PROPOSED S4.55 CHANGE LIST

Project Name
Castlecrag Quadrangle

Drawing Title
BASEMENT 02 PLAN

Drawing No
A10-0800

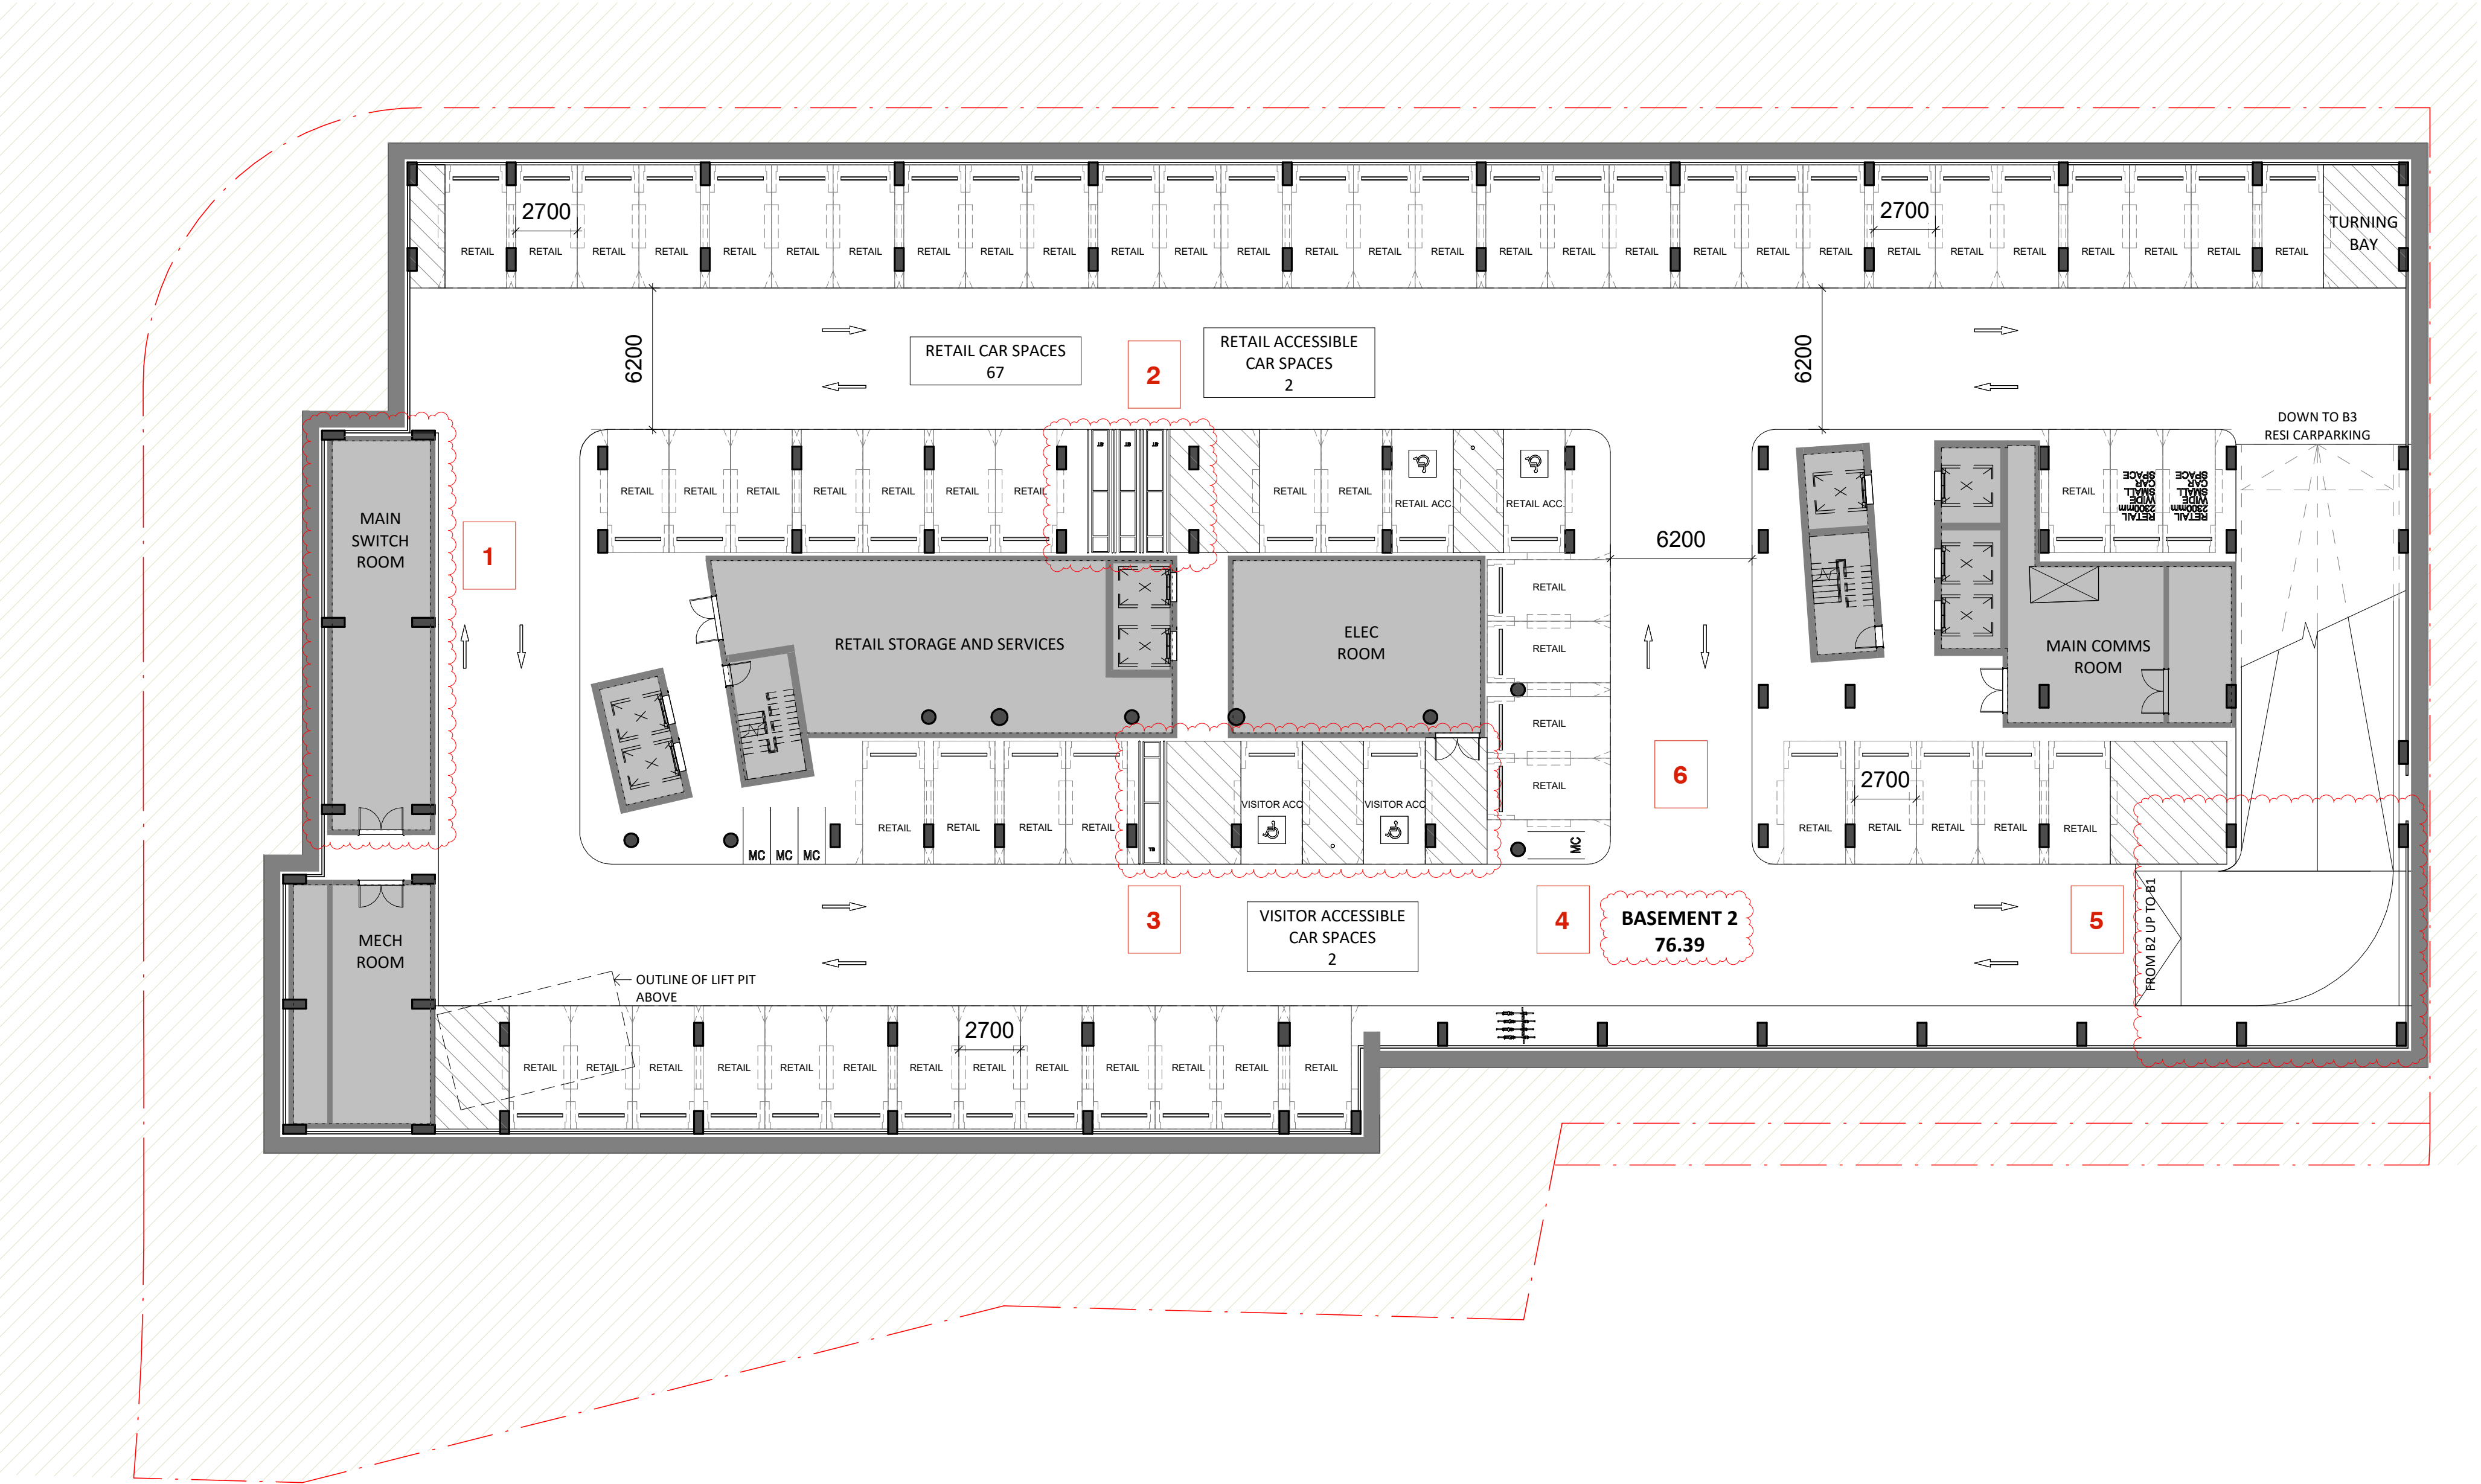
1. PARKING MOVED FROM HERE TO MAKE ROOM FOR THE MAIN SWITCH ROOM
2. TROLLEY BAYS INCLUDED HERE, AND ACCESSIBLE VISITOR PARKING SPACES MOVED HERE FROM LB1
4. LOWERING THE SLAB LEVEL OF THE DA APPROVED BASEMENT 2 TO IMPROVE OPERATIONAL EFFICIENCY, FUNCTIONALITY AND DURABILITY FOR USERS.
5. RAMP DOWN FROM B1 INCREASED TO ACCOMMODATE THE LOWERED BASEMENT LEVEL.
6. COLUMNS INCLUDED AFTER INITIAL CO-ORDINATION WITH THE STRUCTURAL ENGINEER. BASEMENT PERIMETER COLUMNS NEEDED.
